Date Received: 12/10/97	By: Tat	PERMIT NUMBER	ACT/007/020
Title of Proposal: UC-3 Culvert Extension		PERMIT CHANGE #	97D-1
Description:		PERMITTEE	HORIZON COAL COMPANY
# of Copies Required: 5	# of Copies Received: 5	MINE NAME	HORIZON MINE

Date Received 09/18/97	By: tat (Initial)	PERMIT NUMBER	ACT/007/020
Title of Proposal: UC-3 Culvert Extension		PERMIT CHANGE #	97D
Description:		PERMITTEE	HORIZON COAL COMPANY
# Copies Required 5	# Copies Received 5	MINE NAME	HORIZON MINE

The disputed area for the culvert extension lies northward of the current disturbed area boundary as shown in the approved MRP and on photographs (see Figure 1 of this TA memo) taken during construction last fall, 1996. The placement of the disturbed boundary marker as shown in Figure 1 is consistent with the marked disturbance boundary as shown in the original approved Mine Reclamation Plan. However, Horizon claims this area as part of the established disturbance area because of errors in

FIGURE 8-2
GROWTH MEDIUM REMOVAL LOCATIONS
HORIZON No. 1 MINE
 HORIZON COAL CORPORATION
 P.O. BOX 2880
 WISE, VIRGINIA 24278

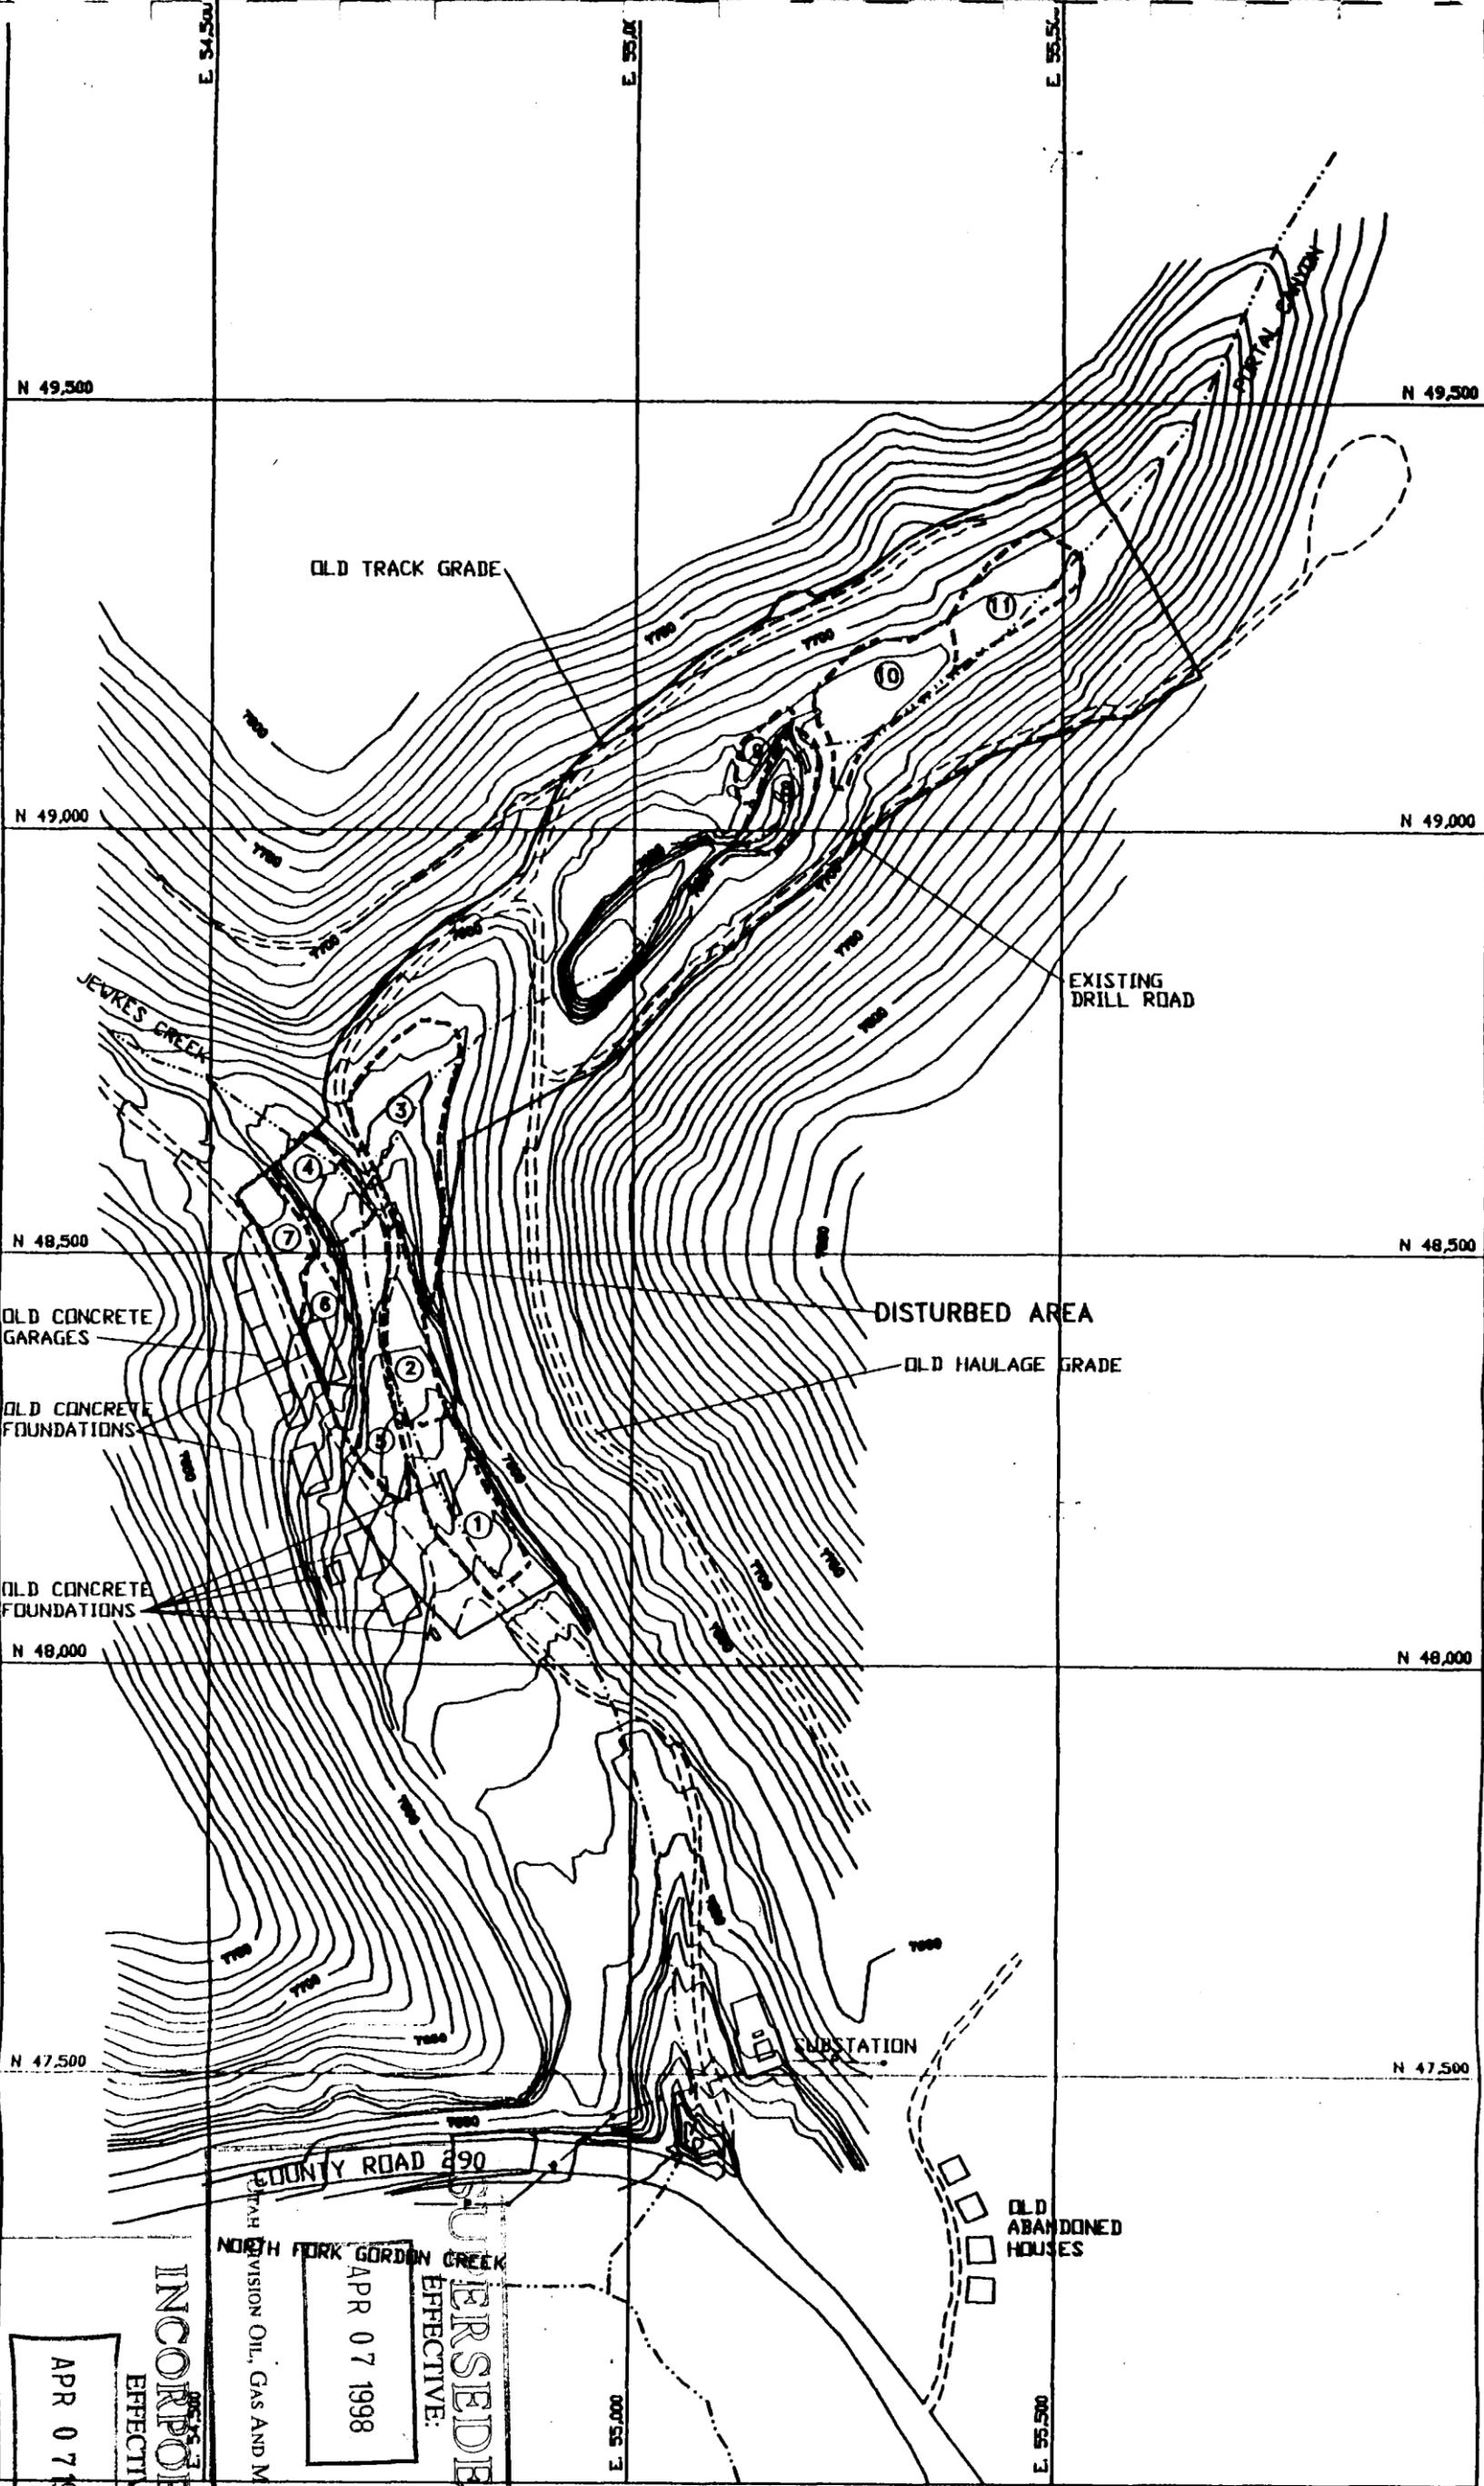
The amendment gives reference to salvaging soils (Area 12, Figure 8-2) from the bottom of Jewkes Creek and along the adjacent hillsides. Jewkes Creek soil salvage (≈ 1.5 ft depth) includes soils located beneath and immediately adjacent the proposed culvert where the channel will be filled and compacted. The east hillside disturbance will be limited, but all available soil medium on the west hillside (≈ 4 ft depth) will be salvaged. The total volume of soil salvage is estimated at 660 CY.

Table 8-3 is updated to reflect the additional 660 CY of soil salvaged from area 12, the culvert expansion area; total soil salvaged from Horizon now shows as 14,330 CY. In addition, Figure 8-2, Growth Medium Removal Locations, has been revised to show Area 12.

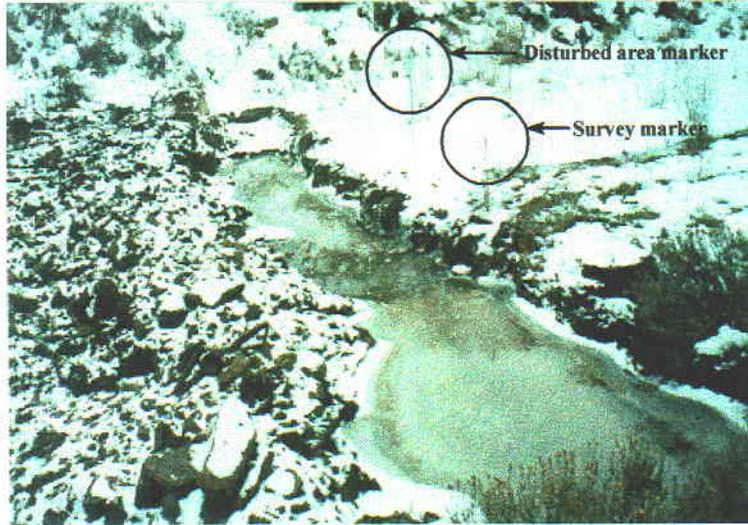
- *Photographs from last fall (Figure 2 of this TA) show that all north, northwest hills located adjacent, immediately above the Portal Canyon pad and below the soil stockpile were disturbed during the 1996 fall construction period. Figure 8-2 clearly shows that no soil was salvaged from these slopes, yet the photograph (TA Figure 2) clearly shows that these hillsides were affected during construction. Therefore, if these slopes were affected during construction, why wasn't soil salvaged?*

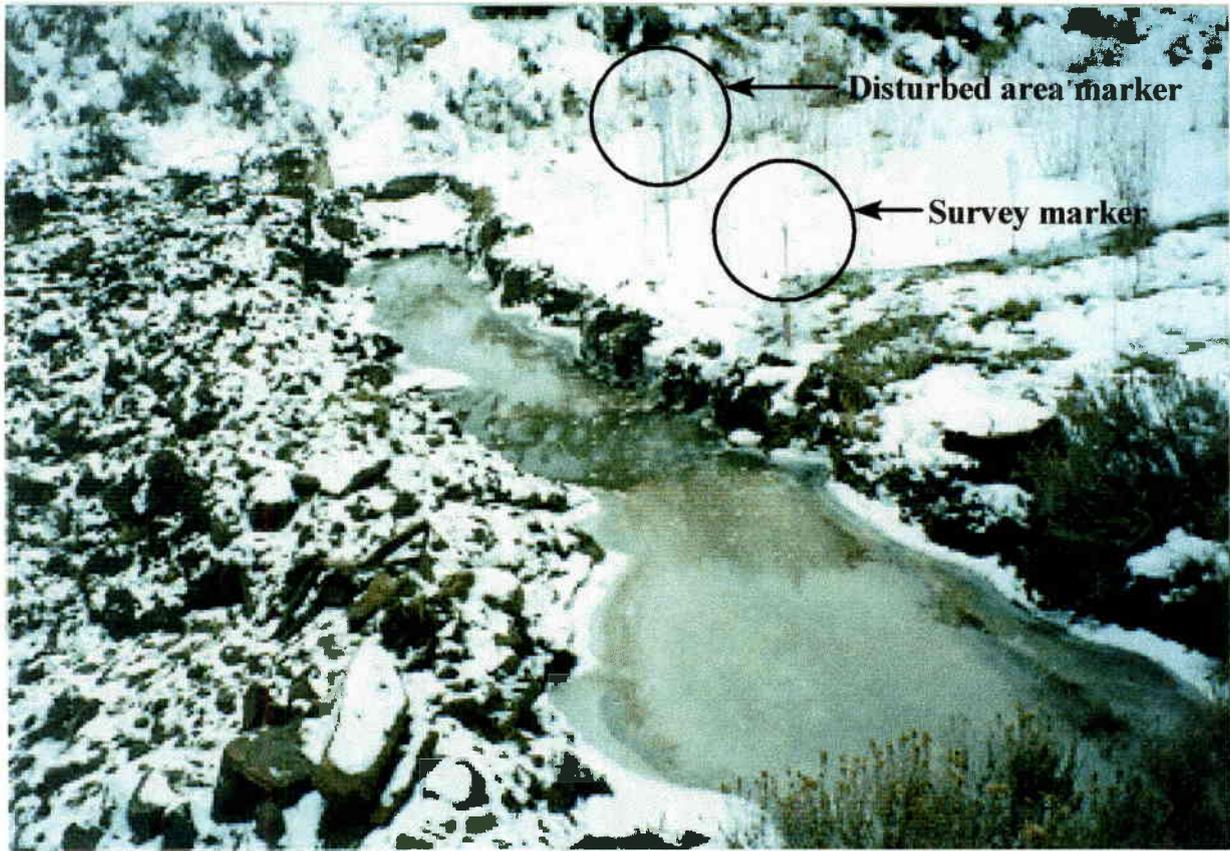
The disputed area for the culvert extension lies northward of the current disturbed area boundary as shown in the approved MRP and on photographs (see Figure 1 of this TA memo) taken during construction last fall, 1996. The placement of the disturbed boundary marker as shown in Figure 1 is consistent with the marked disturbance boundary as shown in the original approved Mine Reclamation Plan. However, Horizon claims this area as part of the established disturbance area because of errors in surveying that were corrected during a survey performed during the summer of 1997. Drawing A, Appendix 3-9, shows the revised disturbance boundary as it exists in the field after the 1997 survey.
